# Access Compliance Report

## Public Rights-of-Way

Intersection ID: 27680	Main Street: LANCASTER_HY	Cross Street: BALLANTYNE_COMMONS_PY	Location: NE
ADA ID: 07262D48832B	Ramp Type: Perp	Initial Pass/Fail: Fail	Overall Compliance: No
Severity Score: 8.75			
Codes/Mitigation Info/Possible Solution		Field Measurements/Component Compliance

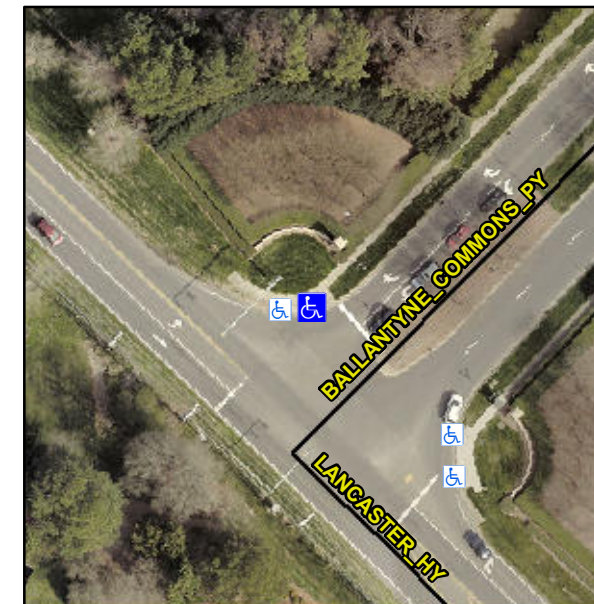
**Not Found, R304.5.1**

Compliance	Description	Data	Compliance	Description	Data
N/A	Ramp Length (in)	62.0	Yes	Ramp Slope (%)	5.1
No	Ramp Width (in)	45.0	Yes	Ramp XSlope (%)	1.0
N/A	Flare Type LT	N/A	N/A	Flare Type RT	N/A
N/A	Flare Slope LT (%)	N/A	N/A	Flare Slope RT (%)	N/A
N/A	Flare Traversable LT?	N/A	N/A	Flare Traversable RT?	N/A
N/A	Landing Length (in)	N/A	N/A	DWS Provided?	N/A
N/A	Landing Width (in)	N/A	N/A	DWS Contrast?	N/A
N/A	Landing Slope (%)	N/A	N/A	DWS Length (in)	N/A
N/A	Landing X Slope (%)	N/A	N/A	DWS Full Width?	N/A
N/A	Landing Curb? (Y/N)	N/A	N/A	DWS Offset (in)	N/A
N/A	Shared Landing?	N/A			
N/A	Gutter Ponding?	N/A	N/A	Gutter Slope (%)	N/A
N/A	Gutter Lip Ht (in)	N/A	N/A	Gutter X Slope (%)	N/A
N/A	Painted X Walk1?	No	N/A	Painted X Walk2?	N/A
	X Walk 1 Direction	To SE		X Walk 2 Direction	N/A
N/A	X Walk 1 Width (in)	N/A	N/A	X Walk 2 Width (in)	N/A
	X Walk 1 Slope (%)	0.2		X Walk 2 Slope (%)	N/A
	X Walk 1 X Slope (%)	3.1		X Walk 2 X Slope (%)	N/A

**Remove & Replace Entire Ramp.**
